SUBJECT: Requests that approval of proposed changes be issued prior to 970430 to support installation & testing of proposed modification prior to restart from upcoming refueling outage re EDG protection during testing re 961114 discovery of deficiency.

SERIAL: HNP-97-092
10 CFR 50.59(c)
10 CFR 50.90

SHEARON HARRIS NUCLEAR POWER PLANT
DOCKET NO. 50-400/LICENSE NO. NPF-63
EMERGENCY DIESEL GENERATOR PROTECTION DURING TESTING

BASIS FOR CHANGE REQUESTBackground

Figure 1

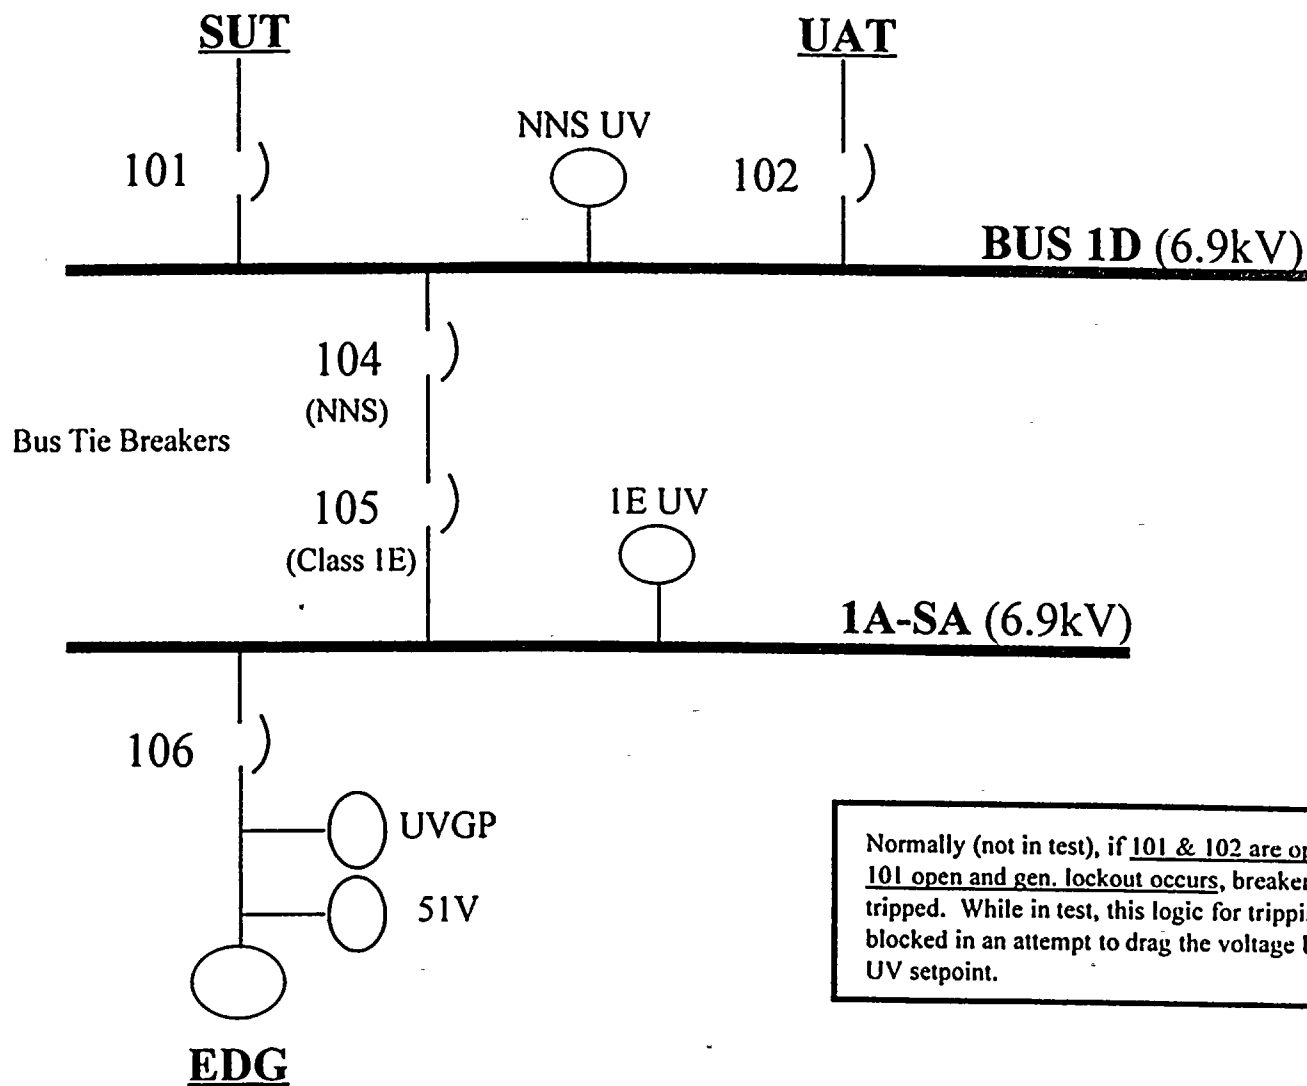
Normally (not in test), if 101 & 102 are open or 101 open and gen. lockout occurs, breaker 105 is tripped. While in test, this logic for tripping 105 is blocked in an attempt to drag the voltage below the UV setpoint.

FIGURE # 2
BREAKER # 105
(MODIFIED BREAKER CIRCUIT BY ESR 97-00005)

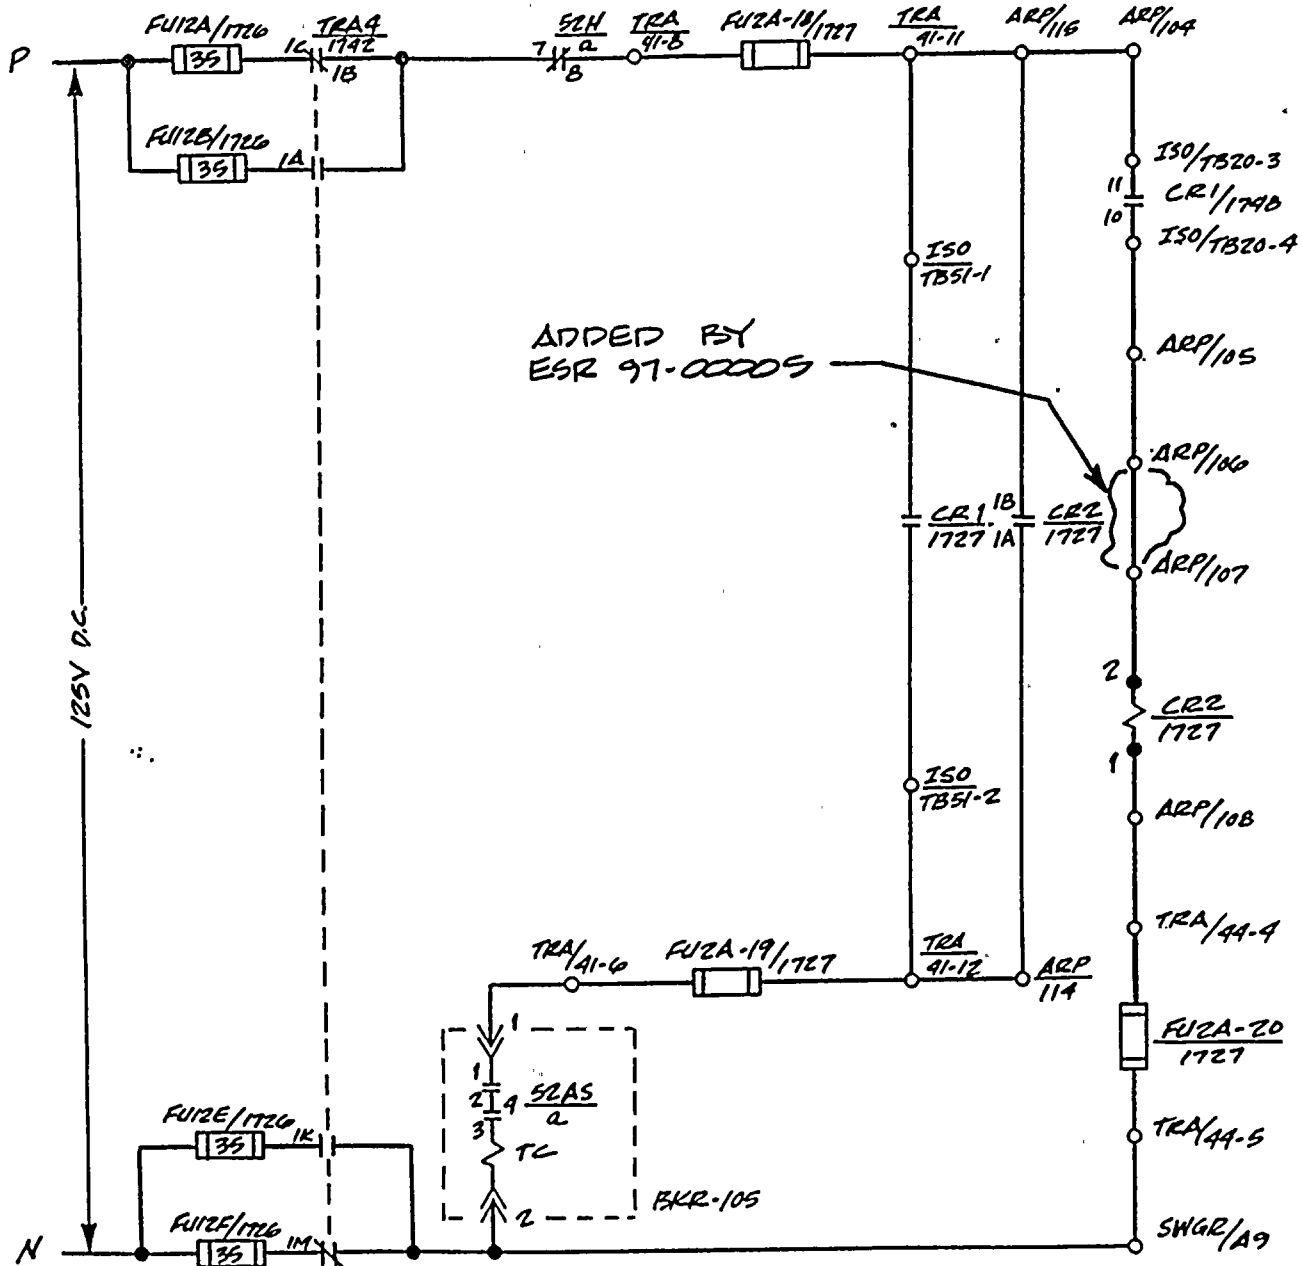
- 1) The logic for the 105 tie breaker between the 1D bus and the 1A-SA bus will be modified to remove contact 2B-2C of relay SM/SA from the breaker trip coil logic (see attached sketch SK-9700005-E-01). This will be accomplished by sparing cable 11727K-SA that runs between the ESS cabinet 1A-SA and the Auxiliary Relay Panel ARP-1A(SA)R3, and placing a jumper in the ARP panel between terminal points 106 and 107.
- 2) The logic for the 106 output breaker of the EDG will be modified to add another parallel path for tripping the breaker when the EDG is in the test mode (see attached sketch SK-97-00005-E-02 Sheet 1 of 2). This additional trip path will utilize contact 1G-1H from

relay CR2/1727 that is in the breaker 105 logic to complete a circuit path through the test mode relay contact (1B-1A of relay SM/SA) energizing relay CR2/1702. Energizing relay CR2/1702 closes contact 1A-1B and completes a circuit path energizing the 106 breaker trip coil.

6.9KV. EMER BUS 1A-SA TO AUX BUS ID TIE BKR 105 SA SH. 2

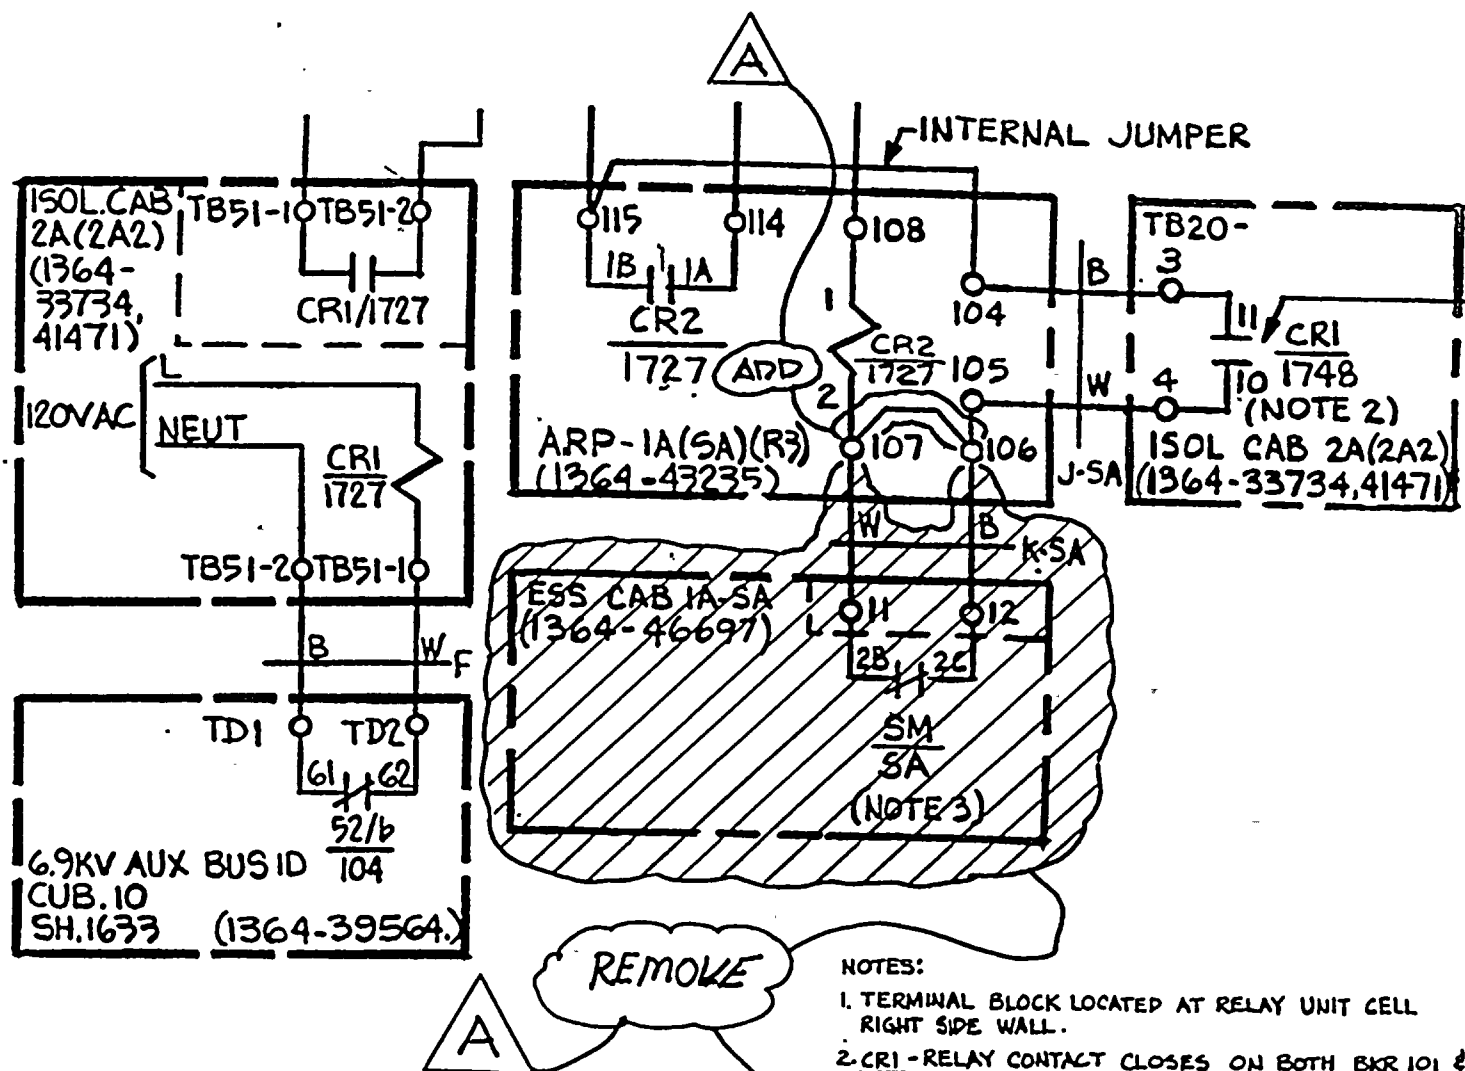
- 3) A Mechanism Operated Cell (MOC) switch (52S/a) of breaker 105 contact is bypassed by adding a jumper between terminal block TB3-45 terminal 2 and terminal block TB3-46 terminal 12, in the transfer panel 1A, sparing cable 11702J-SA. This will eliminate a relay race between breaker 105 MOC switch contact and relay CR2/1702 in the trip logic circuit of breaker 106.

6.9KV EMER. BUS 1B-SB TO AUX BUS
1E THE BKR 125 SB SH, 2

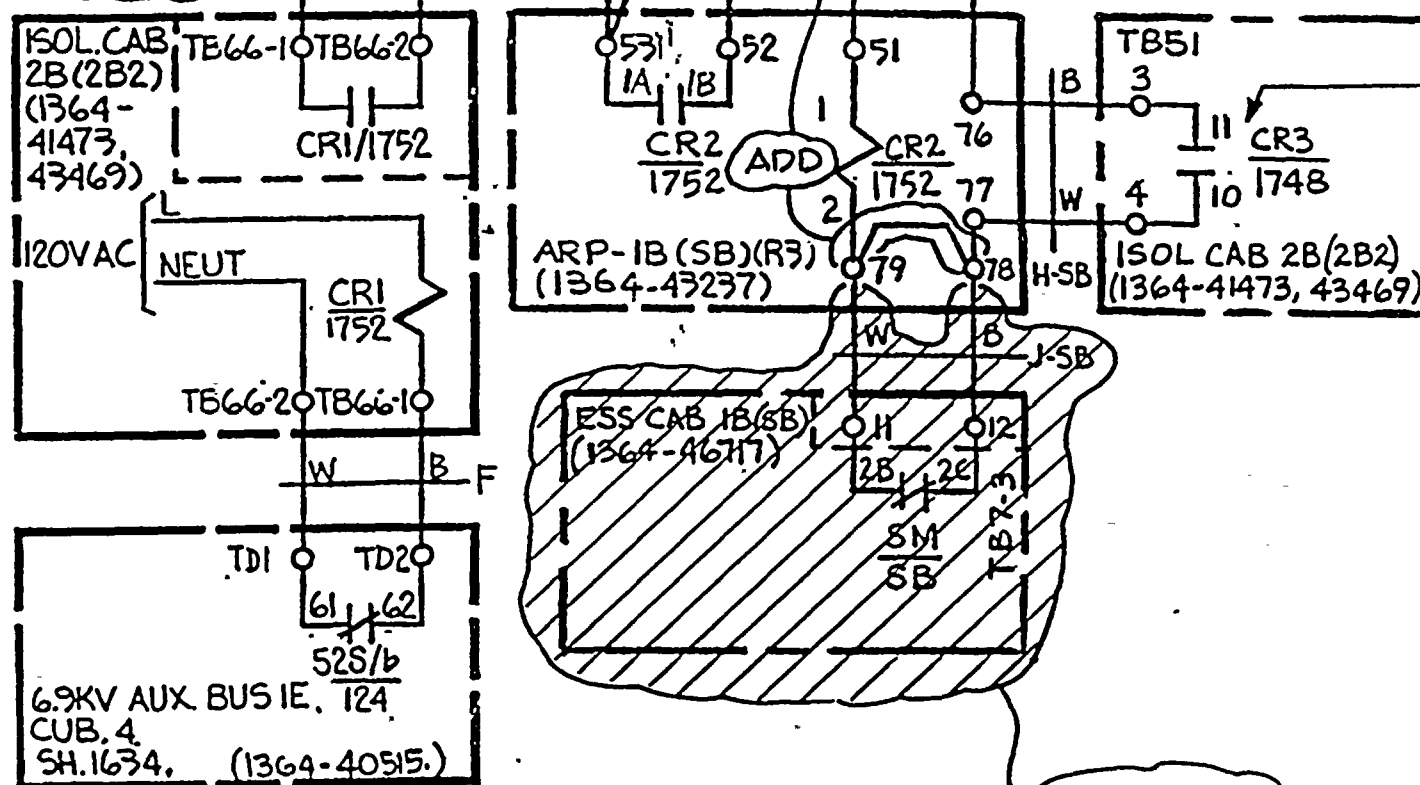
- 1) The logic for the 125 tie breaker between the 1E bus and the 1B-SB bus will be modified to remove contact 2B-2C of relay SM/SB from the breaker trip coil logic (see attached sketch SK-9700005-E-05). This will be accomplished by sparing cable 11752J-SB that runs between the ESS cabinet 1B-SB and the Auxiliary Relay Panel ARP-1B(SB)R3, and placing a jumper in the ARP panel between terminal points 78 and 79.

- 3) A Mechanism Operated Cell (MOC) switch (52S/a) of breaker 125 contact is bypassed by adding a jumper between terminal block TB3-45 terminal 2 and terminal block TB3-46 terminal 12, in the transfer panel 1B, sparing cable 11750-J-SB. This will eliminate a relay race between breaker 125 MOC switch contact and relay CR2/1750 in the trip logic circuit of breaker 126.

EMERGENCY DIESEL GEN. 1B-SB
BREAKER 126 SB SH. 2

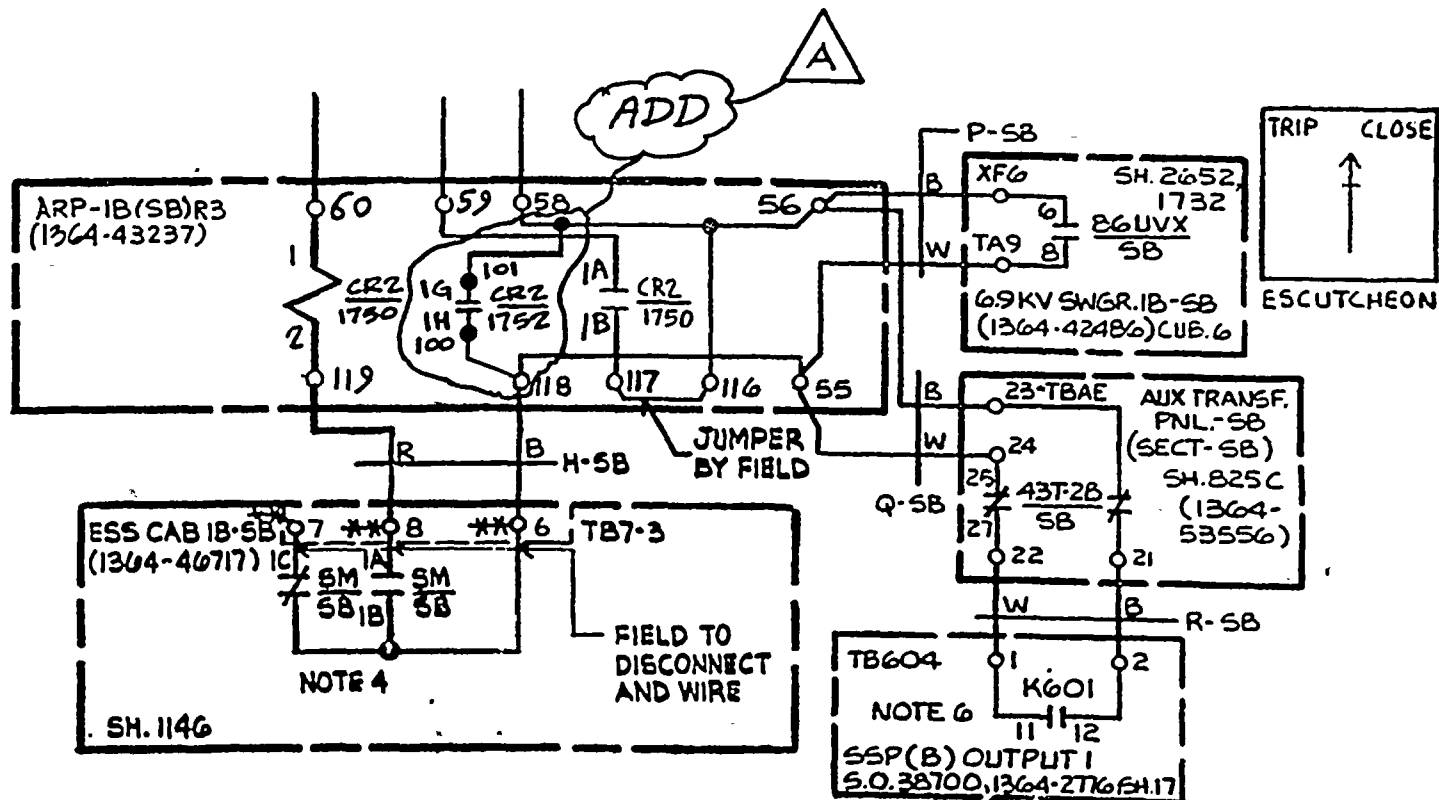
- 2) The logic for the 126 output breaker of the EDG will be modified to add another parallel path for tripping the breaker when the EDG is in the test mode (see attached sketch SK-9700005-E-06 Sheet 1 of 2). This additional trip path will utilize contact 1G-1H from relay CR2/1752 that is in the breaker 125 logic to complete a circuit path through the test mode relay contact (1B-1A of relay SM/SB) energizing relay CR2/1750. Energizing relay CR2/1750 closes contact 1A-1B and completes a circuit path to energize the 126 breaker trip coil.

DIESEL GENERATOR
LOGIC DIAGRAM
FIGURE 8.3.1-1

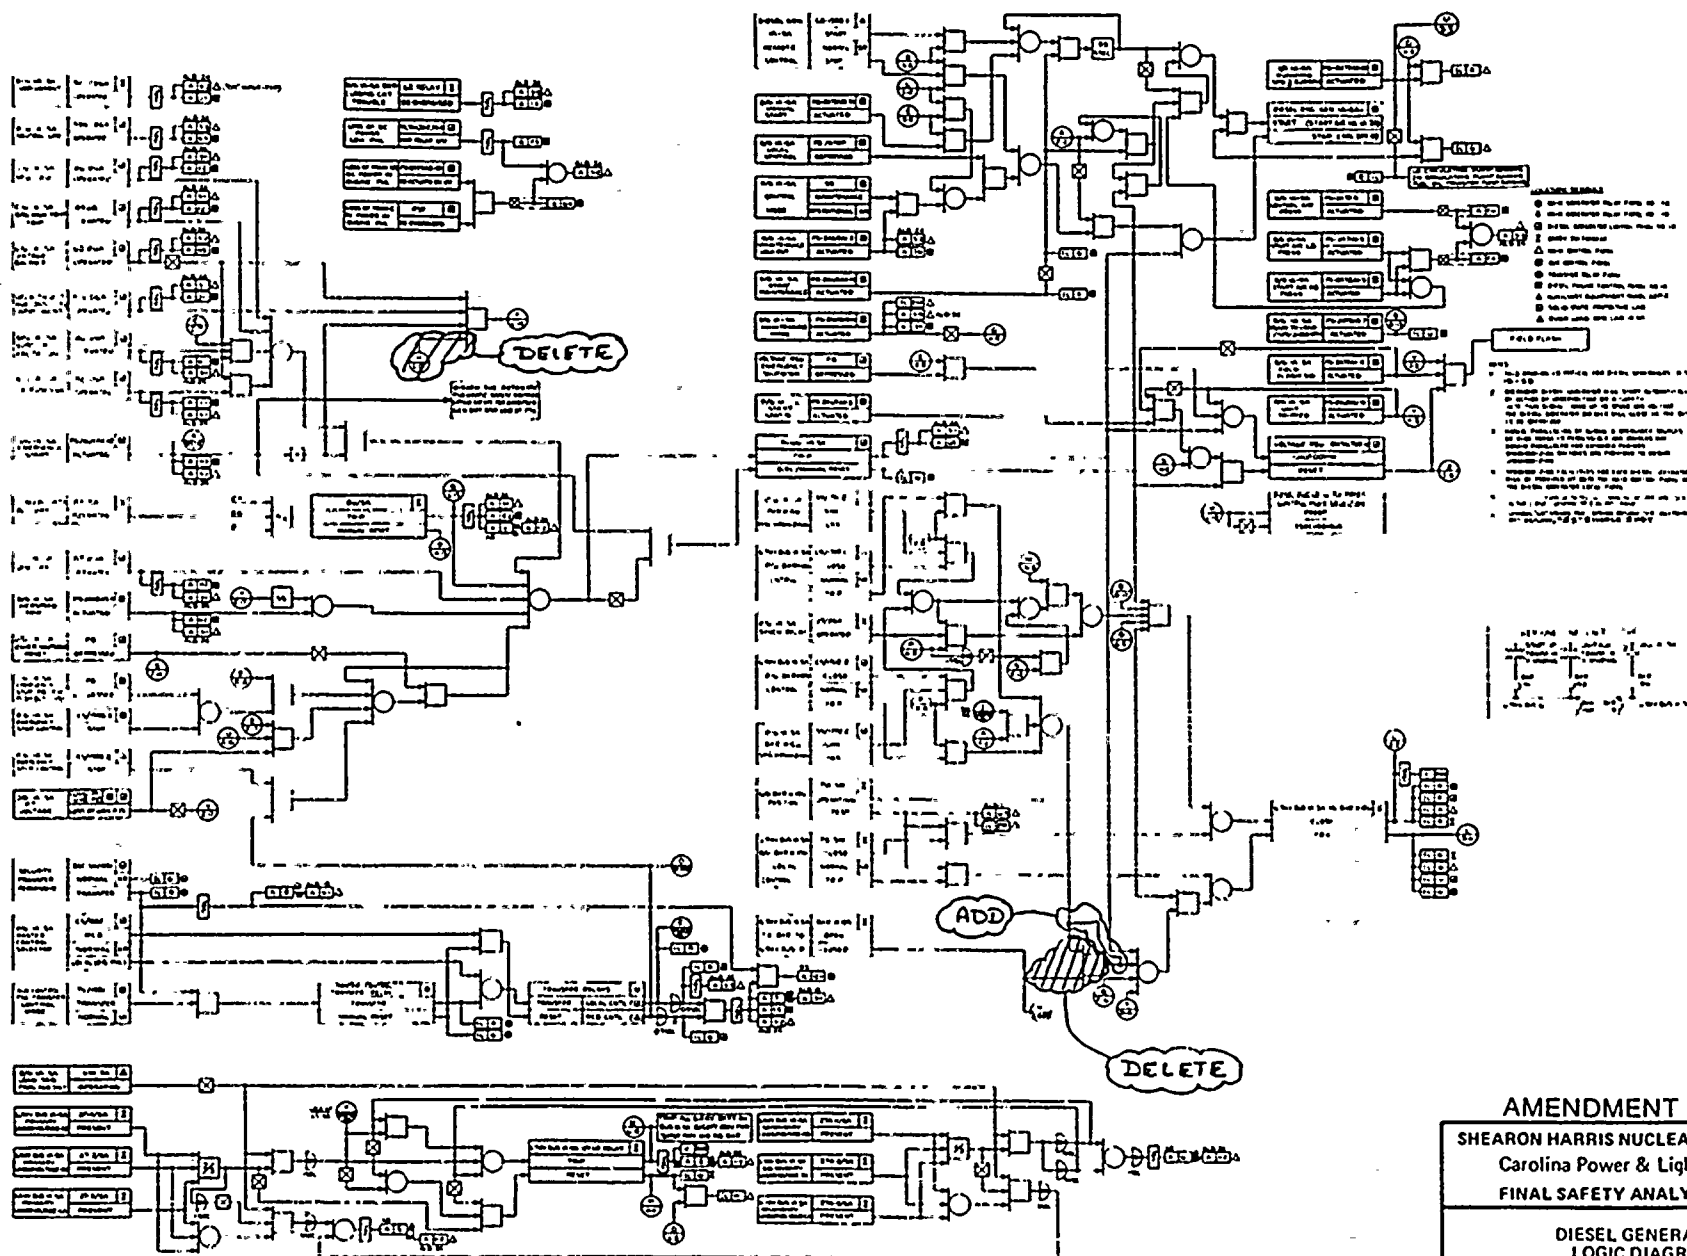
ADD WITH THE EXCEPTION OF DURING DIG TEST MODE THE NON-CLASS 1E RELAY AND ITS POWER SUPPLY, RECEIVING SIGNAL FROM UAT AND SAT BREAKER POSITION OR SAT BREAKER POSITION AND GENERATOR LOCK OUT, WILL TRIP THE D/GA^{OUTPUT}BREAKER AND THE NON-SAFETY BUS TO ESP BUS TIE BREAKER.

- e) On receipt of LOSP during the D/G test mode:
- 1) Trip the offsite breaker feeding the ESF bus and the D/G breaker if closed. IF THE D/G BREAKER FAILS TO TRIP, OPERATOR ACTION WILL BE REQUIRED TO TRIP THE D/G BREAKER. ADD
